Anthony V. Cruz
Docket No. 0198
Serial No. 09/435,507

Remarks

FIG-1

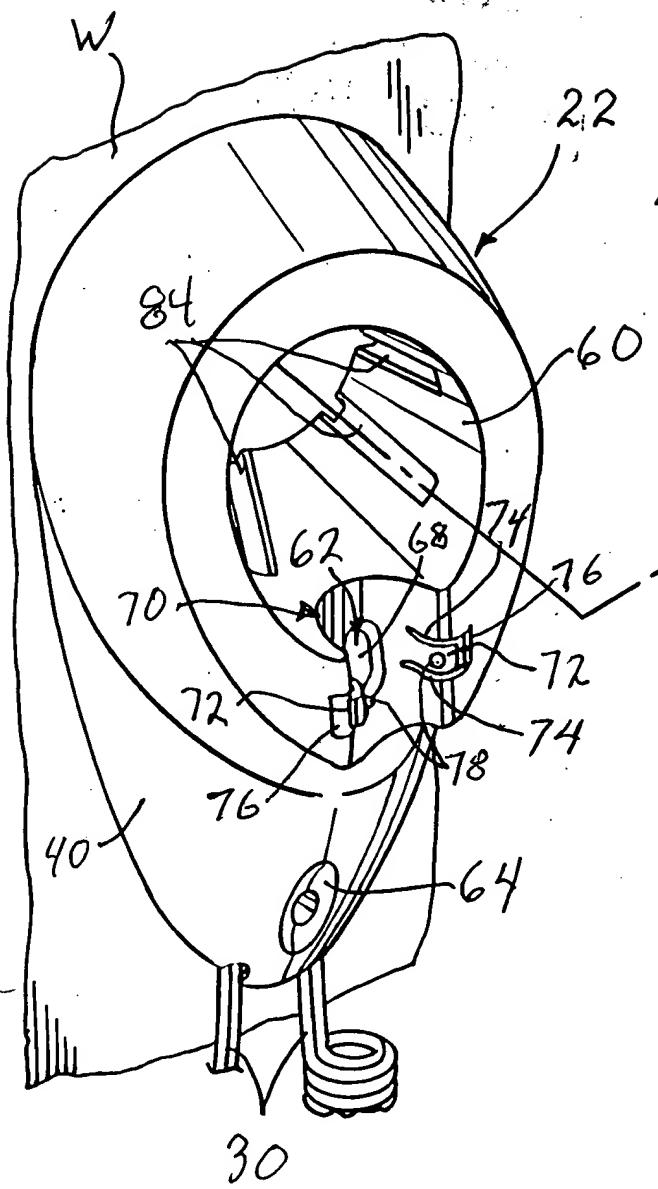
Change reference number "40" on the right side of FIG. 1 to "39", extend the lead line from the right side reference number "72" to the jaw denoted thereby, and add reference numbers "75", "76", "78" and "80" to FIG. 1 as indicated in red on a copy of FIG. 1 submitted herewith.

The proposed amendments to FIG. 1 are requested partly to change the reference number "40" applied to the blower screen or guard in FIG. 1 to "39" because "40" is also used to denote the front face of the wall mount. This conforms to the proposed revision to the specification in the paragraph beginning at page 6, line 9. In addition, several reference numbers are proposed to be added to FIG. 1 and a lead line extended in FIG. 1, all in
